NOTICE OF DECISION

PLANNING COMMISSION ADOPTED STAFF REPORT

**U-Haul – COMMERCIAL DEVELOPMENT
Type III Site Design Review
Type III Conditional Use Permit**

Land Use File Numbers DR-70-23 and CUP-02-03

Proposed Site Plan – City File: DR-70-23 & CUP-02-23

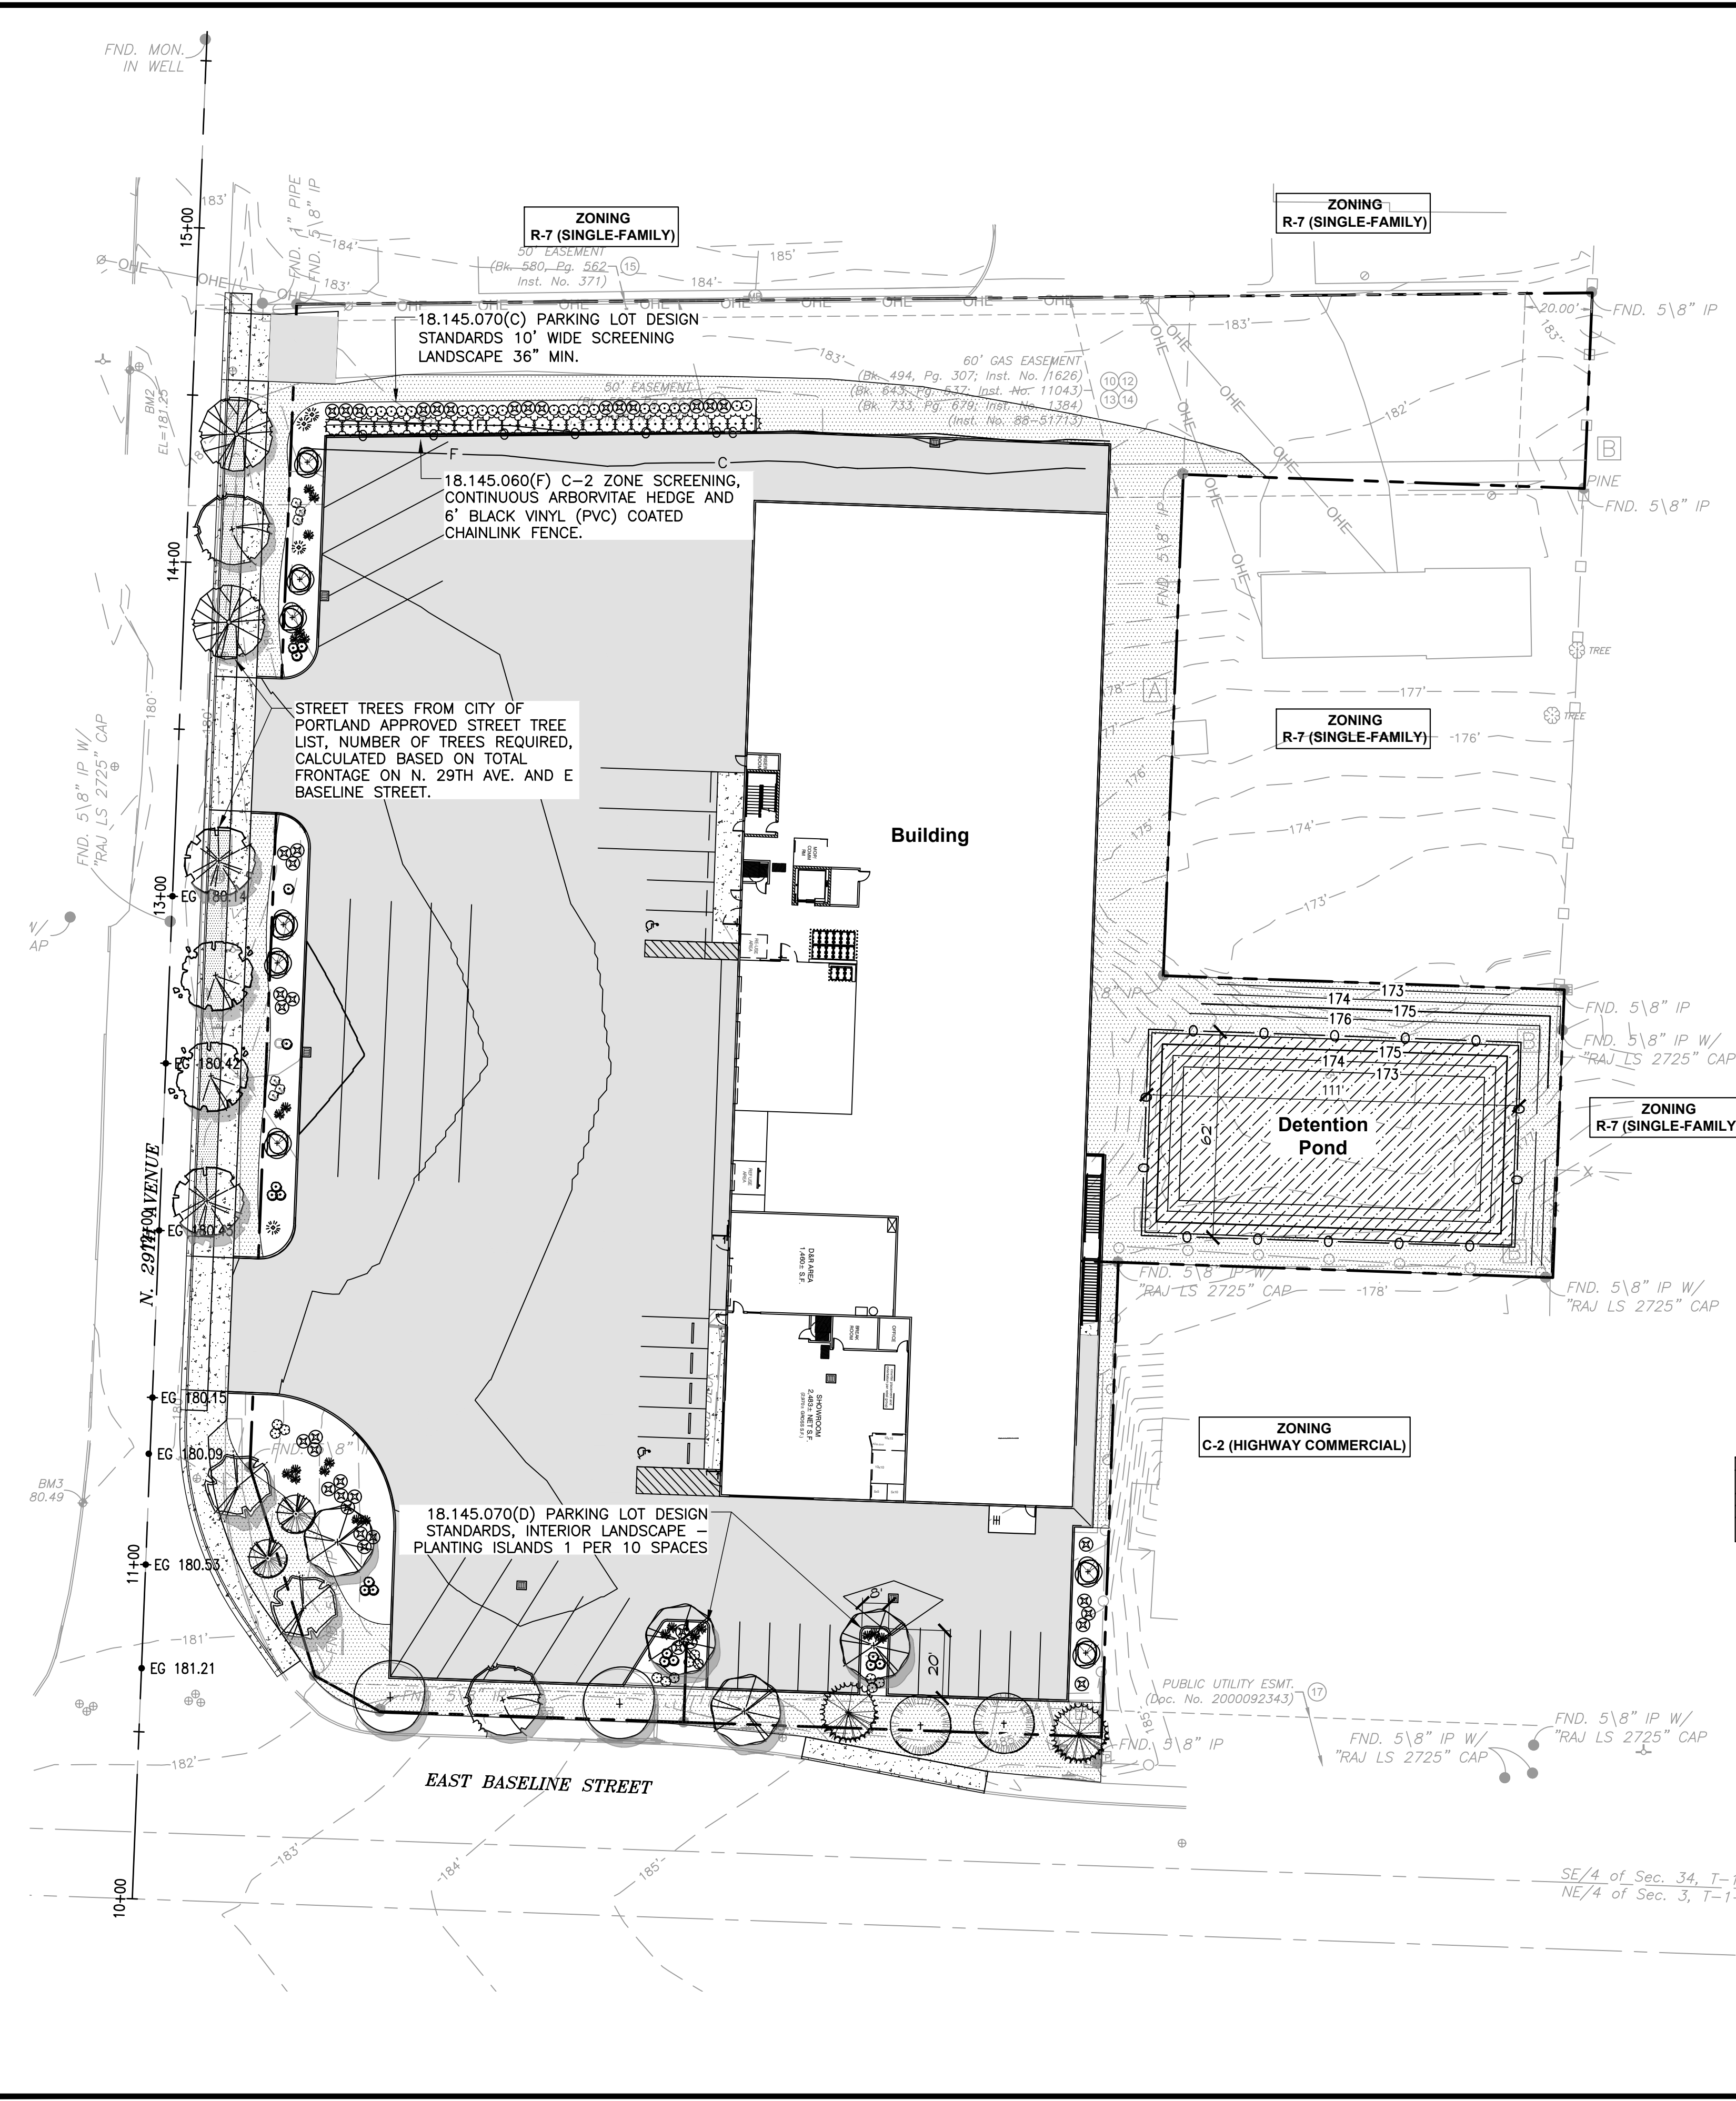
The site plan does not show the clear vision areas, however when applying a scale to the landscaping plan, the trees near the driveways appear to be outside of the 15-foot clear vision areas. A condition of approval shall require that the clear vision areas per CMC 18.150.070 at the driveways along N. 29th Avenue be met.

The site plan shows the southern driveway from N. 29th Avenue is approximately 95-feet from the intersection of Baseline Street and N. 29th Avenue. This is slightly less than the 100-foot spacing standard, as identified above. The applicant acknowledges this distance, but describes the driveway is directly across from another access to the west and that City Staff mandated this alignment. When the applicant held the required pre-application conference with the City (PAC-02-23), the City Engineer did note that the proposed southern driveway would need to align with the existing driveway that is on the west side of N. 29th Avenue.

parking spaces, there are no internal marked pedestrian crossings to the front door. Staff finds the site plan also does not provide or show pedestrian connectivity from the public sidewalks to the main entrance of the building. A pedestrian connection from the Baseline Street sidewalk to the front door can be reasonably accommodated, which will also benefit customers parking in this area. Therefore, prior to building permit submittal, a revised site plan shall be provided to the Community Development Department that shows a pedestrian connection from the Baseline Street sidewalk to the front door of the building. The internal pedestrian connection that crosses the internal drive-aisle shall be striped. This shall be a condition of approval.

public facilities to the nearby residential neighborhoods. The distance of 35-feet, per the CMC, is the maximum distance that a driveway may be approved to unless approved by the reviewing body. Staff finds the site can be functional with 35-foot-wide driveways, as other commercial properties also have large vehicles entering and exiting their sites. Therefore, the plans to be reviewed and approved by the City Engineer and shall be adjusted for driveways not to exceed 35-feet in width. This shall be a condition of approval.

The applicant proposes a 6-foot black vinyl coated chain link fence on the site. The proposed fencing will enclose the water quality facility, and provide a barrier along the northern edge of the main parking lot and along the property line from the water quality facility south to Baseline Street. Staff finds that the proposed fencing with landscaping along the northern edge of the main parking lot will provide screening for the abutting dwellings to the north. The dwellings to the east will be screened by fencing around the perimeter of the water quality facility and by the back side of the building. The proposed fencing meets the standard as it is not galvanized. To ensure the fencing remains compliant, a condition of approval shall require non-galvanized fencing. This shall be a condition of approval.
